The Proposed Combustion Turbine (CT) and Industrial
Boiler (IB) MACT Rules
The Potential Impact on the Utility Industry

Richard McRanie
Russell Berry
RMB Consulting & Research, Inc.
5104 Bur Oak Circle
Raleigh, NC 27612
919-510-5102

The EPRI CEM Users Group Meeting
May 14-16, 2003
San Diego, CA

Figure 1. Combined Cycle CT with Auxiliary Burners - Cross Section

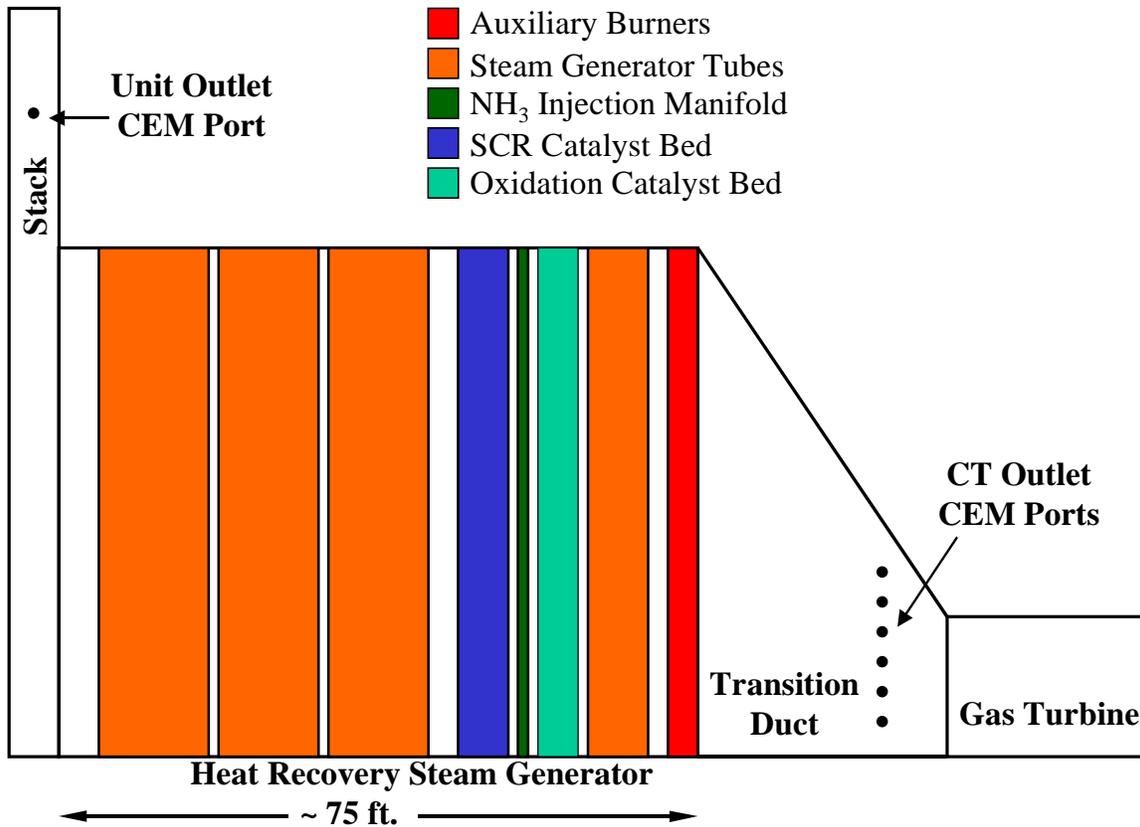
It is impossible because, on a combined-cycle unit, the auxiliary burners are physically located inside the heat recovery steam generator (HRSG) prior to the NO_x reduction catalyst and oxidation catalyst. (Both catalyst beds are also mounted in the HRSG - see Figure 1.) Therefore, any CO produced by the auxiliary burners will also be treated by the oxidation catalyst. A simple example will illustrate the point. Assume that the CT is operating without auxiliary burners and is producing 5 ppm CO. If 95% reduction is achieved the outlet CO concentration will be 0.25 ppm. Now assume that we light the auxiliary burners and they add another 5 ppm CO for a total of 10 ppm. At 95% reduction the outlet CO concentration will be 0.5 ppm. To achieve the "apparent" compliance level of 0.25 ppm level on the outlet will require 97.5% CO reduction across the oxidation catalyst.

Since measurements of the CO contributed by the CT alone cannot be made when the auxiliary burners are operating, the compliance procedure proposed by EPA is impossible to do on combined-cycle units equipped with duct burners.

While not an impossible measurement on combined-cycle units without auxiliary burners or simple-cycle CTs, the differential CO measurement proposed by EPA is very difficult to do on a continuous basis. If one again refers to Figure 1 and ignores the auxiliary burners, the figure depicts a combined-cycle unit without auxiliary burners. While, in theory, the differential CO compliance test is possible to conduct on a combined-cycle unit when there are no auxiliary burners, or a simple-cycle unit, this measurement will be difficult because of the unrepresentative nature of the CT outlet sampling location. The gas in this location is very aggressive - the temperature is 1000 degrees F, the pressure is in the range of 20-40 inches of water and the velocity is hundreds of feet per second. Also, depending on the design of the CT, this flow stream may be highly stratified in terms of CO, O₂ and CO₂ concentration and velocity.

If the flow is stratified with respect to CO, O₂, or CO₂, a gas sampling probe matrix containing 16-48 sampling probes must be installed to adequately sample the cross sectional area of the duct.² A balanced flow manifold would have to be designed to ensure balanced flow through all of the probes. In addition, some type of cooling mechanism would have to be designed to cool the gas from 1000 °F down to about 350-400 °F before the sample enters the Teflon sampling line. The sampling system design is a challenging engineering design and fabrication problem that we do not believe has ever been done for a continuous analyzer measurement system. In any event, as will be discussed later, CO analyzers are not available to make the appropriate catalyst outlet CO measurements so the entire concept is unnecessary and futile.

Therefore, we suggest that an appropriate demonstration of the formaldehyde emissions or the continuing performance of the catalyst would be a periodic CO or formaldehyde test when the unit is operating in diffusion flame mode. A yearly test should be adequate. It should be noted that this approach would also solve the duct burner problem on combined cycle units because the duct burners could be turned off for the duration of the test. This approach would also solve the CO measurement issues discussed in these comments.
